AnswerMate Replies

- The schematic diagram of my "AnswerMate" (Fig. 1) in the April issue has some errors in the vicinity of the telephone line input circuit.

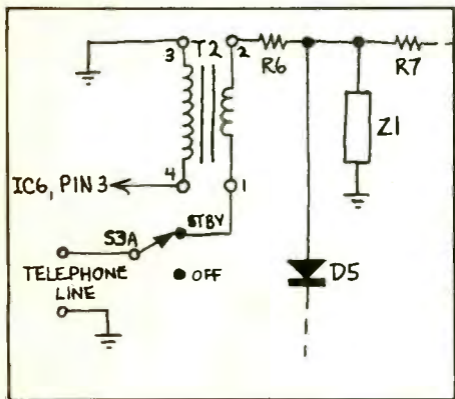
Enclosed is a correct drawing of the circuit. The wiring diagram of Fig. 6 is ok, except that polarity of LED 2 (answer) is shown reversed from what it should be. As far as I can tell the printed-circuit layout of Fig. 4 is correct.
